<b>Office Action Summary</b>	<b>Application No.</b> 10/766,031	<b>Applicant(s)</b> HATA ET AL.	
	<b>Examiner</b> Matthew C. Landau	<b>Art Unit</b> 2815

## **DETAILED ACTION**

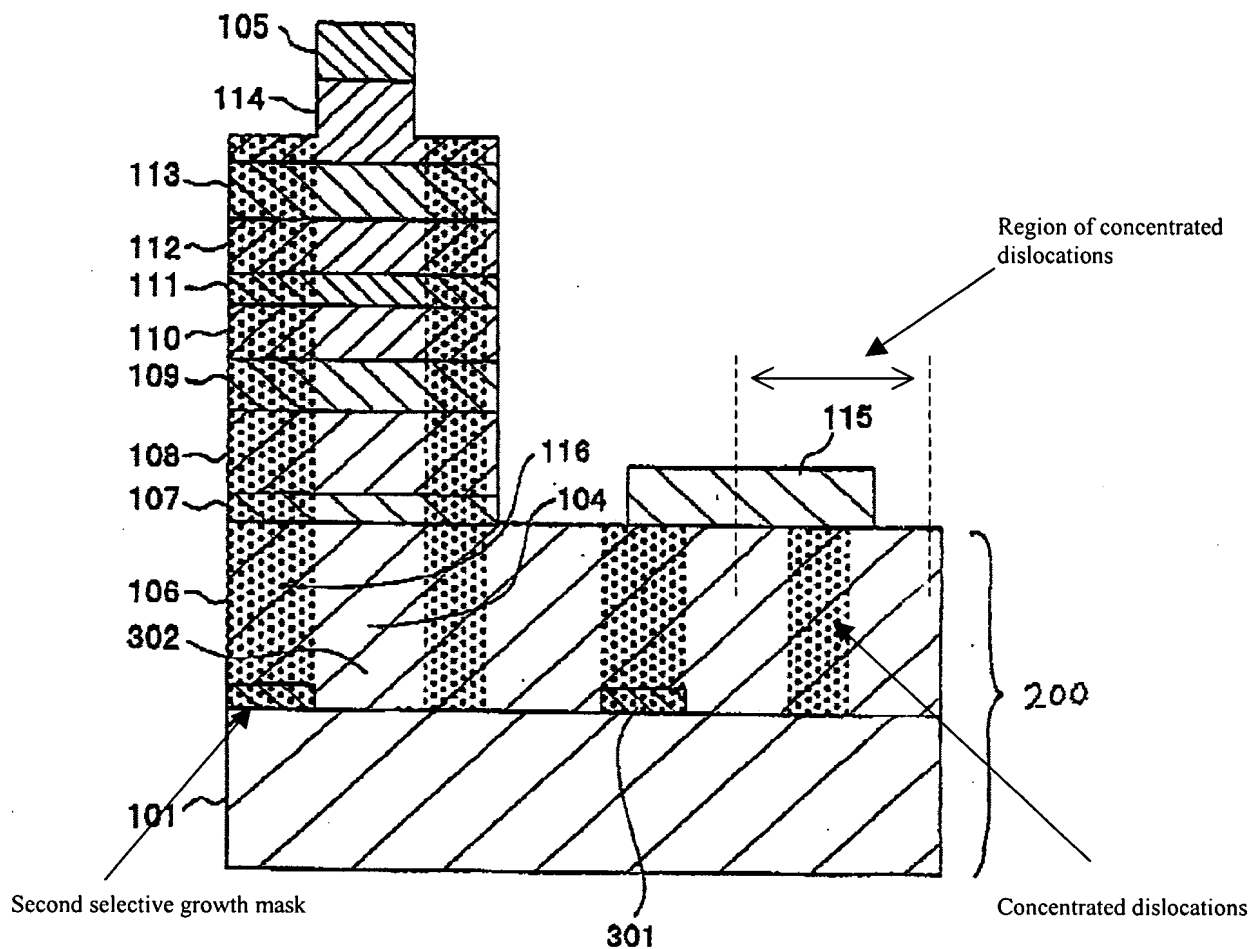
Regarding claim 18, as best the examiner can ascertain the claimed invention, Figure 3 of Yamaguchi discloses a semiconductor element layer (107-114) formed on the front surface of a substrate 200 and provided with a region of the front surface having concentrated dislocations 116 at least on part of the front surface thereof while including an active layer 110; and a front electrode 105 formed to be in contact with a region of the front surface of said semiconductor element layer other than said region of the front surface having said concentrated dislocations, wherein the upper surface of said region of the front surface having said concentrated dislocations is partially removed by a prescribed thickness and located downward beyond said active layer.

Regarding claim 19, Figure 3 of Yamaguchi discloses the active layer 110 is formed in a region of the front surface of the semiconductor element layer other than said region of the front surface having said concentrated dislocations. Note that Fig. 3 shows the active layer 110 is formed in both the region with the dislocations, and the region without the dislocations.

Regarding claim 21, Figure 3 of Yamaguchi discloses a substrate 107/200 including a first region (region of layer 107) having a first thickness and a second region (region of layer 200 to the right of layer 107) provided with a region of the front surface having concentrated dislocations at least on part of the front surface thereof while having a second thickness smaller than said first thickness; a semiconductor element layer (108-114) formed on said first region of

the front surface of said substrate other than said second region provided with said region of the front surface having said concentrated dislocations, said semiconductor element layer includes an active layer 110; and a front electrode 105 formed to be in contact with the front surface of said semiconductor element layer.

Regarding claim 22, Figure 3 of Yamaguchi discloses the semiconductor element layer includes: a first conductivity type (n-type) first semiconductor layer 108, an active layer 110 formed on said first semiconductor layer, and a second conductivity type (p-type) second semiconductor layer 111 formed on said active layer.

Regarding claim 24, Figure 3 of Yamaguchi discloses a substrate 200 provided with a region of the front surface having concentrated dislocations at least on part of the front surface thereof (see below figure); a first selective growth mask 301 formed on a region of the front surface of said substrate located inward beyond said region of the front surface having said concentrated dislocations with a width smaller than the width of said region of the front surface having said concentrated dislocations (see below figure); a semiconductor element layer (107-114) formed on a region of the front surface of said substrate other than a region formed with said first selective growth mask; and a front electrode 105 formed to be in contact with a portion of the front surface of said semiconductor element layer located inside said first selective growth mask. Note that “a region of the front surface having concentrated dislocations” can be any arbitrarily defined region of the substrate, as long as the region includes concentrated dislocations. The below marked up version of Yamaguchi’s Fig. 3 indicates what region is considered to be the claimed “region of the front surface”.

Regarding claim 25, Figure 3 of Yamaguchi discloses a second selective growth mask (see below figure) formed on a region located outward beyond said first selective growth mask at a prescribed interval from said first selective growth mask 301.
